DEFENSE NUCLEAR FACILITIES SAFETY BOARD

HANFORD TANK FARMS SAFETY BASIS REVIEW

Defense Nuclear Facilities Safety Board Technical Report

SEPTEMBER 2021

Figure C-1. Mass of respirable waste released from a DST by a headspace detonation that causes dome failure. Recreated from Figure C-16 in [C-4].

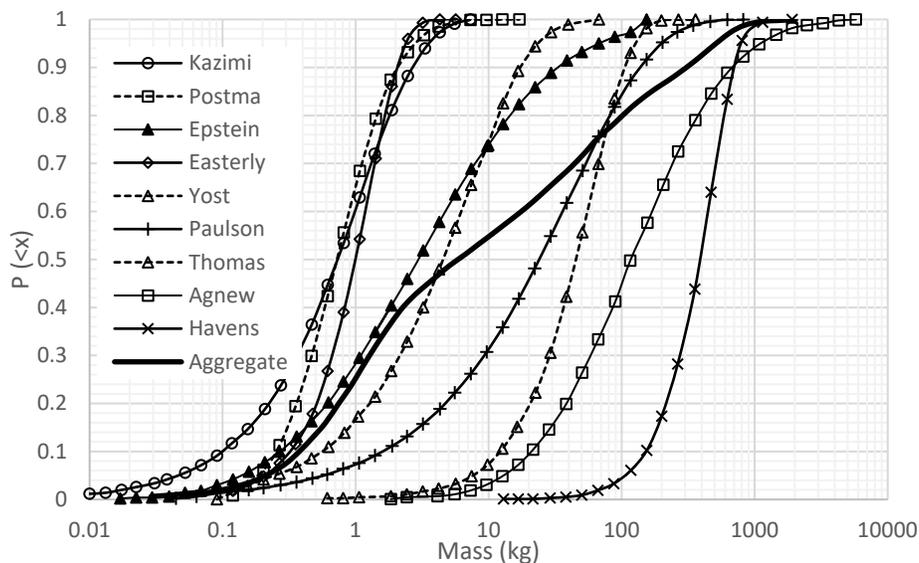
Expert Elicitation Results. The technical bases for the analyzed doses are documented in [C-2] and [C-3]. A key input into the calculations is the amount of respirable mass released as a result of a detonation or deflagration in a vessel headspace. To estimate these releases, an expert elicitation process was used. Figure C-1 below shows an example of the estimated respirable mass released due to a detonation in the headspace of a DST that results in the vessel dome failing [C-4]. Probability distributions elicited from nine experts are shown. The solid curve is the aggregate mean of the nine distributions. The vertical axis is the estimated probability that the actual value of mass released is less than a given mass on the horizontal axis. Similar curves were generated for flammable gas accidents in SSTs for which seven experts were elicited [C-5]. The DSA utilizes these aggregate mean distributions for selecting values used in dose consequence analysis.

Figure C-2. Aggregate mean respirable mass suspended/released from a deflagration accident in Hanford Waste Tanks used for on-site dose consequence analysis in DSA. DST data recreated from Figure C-15 in [C-4]. SST data recreated from Figure A3-A16 in [C-5].

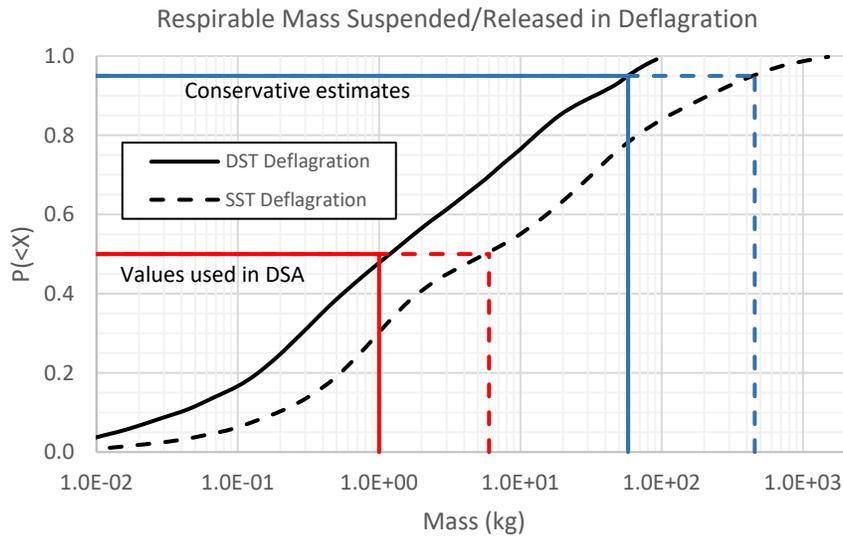
Figure C-2 below shows the expert elicitation results for aggregate mean mass released¹ for deflagration accidents in DSTs and SSTs. In applying this information to compute on-site dose estimates, the DSA used the 50th percentile estimated value of mass released. These are the

red lines shown in Figure C-2, corresponding to a mass of 1.0 kg for DSTs² and 5.7 kg for SSTs (which the DSA rounds up to 6 kg). The 50th percentile is the median value of a distribution and is typically considered to be the best estimate given an uncertain range of potential values. The masses corresponding to the reasonably conservative 95th percentile values of the median aggregate curves in Figure C-2 are 58 kg for DSTs and 455 kg for SSTs (blue lines in Figure C-2). These values are approximately 58 – 76 times larger than that the values used in the DSA.

Figure C-3. Aggregate mean respirable mass suspended/released from a detonation accident in a Hanford single or double shell tank from Figure C-16 in [C-4].

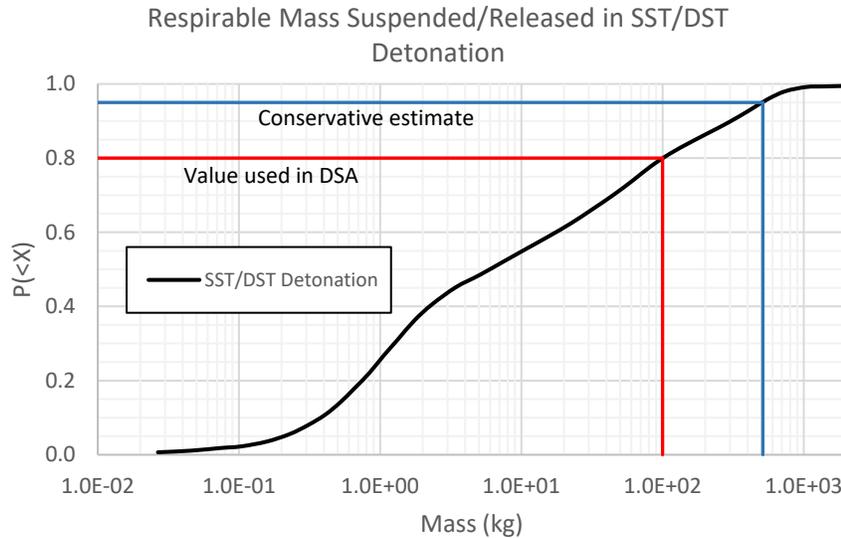
Figure C-3 below shows the aggregate mean respirable mass suspended/released for detonation accidents in an SST or DST. In applying this information to compute off-site dose estimates, the DSA used a mass of 100 kg, which is approximately the 80th percentile (the red line shown in Figure C-3) [C-3]. While the 80th percentile is a more conservative estimate than the 50th percentile used for on-site dose estimates, 20 percent of the potential values still exceed this value. The mass corresponding to the 95th percentile conservative estimate in Figure C-3 is 513 kg, which is about a factor of 5 higher than the value used in the DSA.

Figure C-4. Expert elicitation results for total mass suspended (left) and respirable fraction (right) for the deflagration accident in Hanford single shell tanks. From Figures A3-A16 and A3-A17 in [C-5].

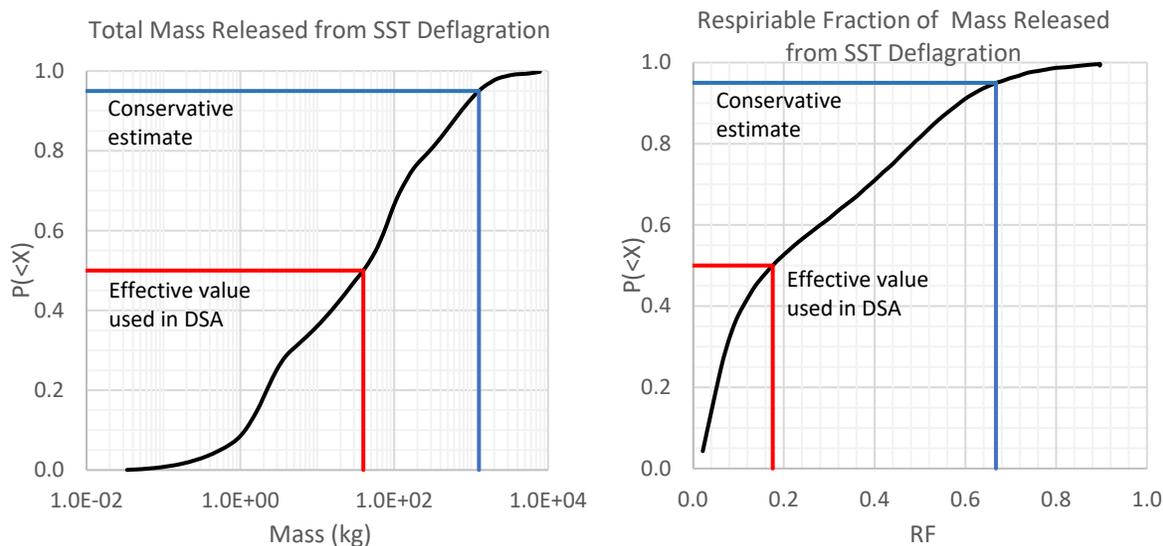
To illustrate the degree of non-conservatism resulting from using distributions for respirable mass, consider Figure C-4 below, which shows the individual distributions of total mass released and respirable fraction for deflagration events in SSTs. The respirable mass for this accident used in the DSA was shown in Figure C-2 to be 5.7 kg. The 50th percentiles for total mass released (40 kg) and respirable fraction (0.17) are shown in red in the Figure C-4. When these values are multiplied together, the respirable mass is about 6.8kg, which is close to the median value from the aggregate respirable mass distribution, suggesting the DSA effectively used median values for both total mass and respirable fraction. From Figure C-4, the 95th percentile conservative value of total mass released is 1260 kg, and the 95th percentile conservative value of respirable fraction is 0.67. A conservative estimate of respirable mass released is obtained by the product of these two conservative values³, resulting in a respirable mass released of about 840 kg. Note the additional conservatism in this result compared with the 95th percentile of the respirable mass distribution shown in Figure C-2, which was 455 kg. This additional conservatism is achieved when conservative values for each input parameter are selected, consistent with the requirements in DOE-STD-3009-1994.
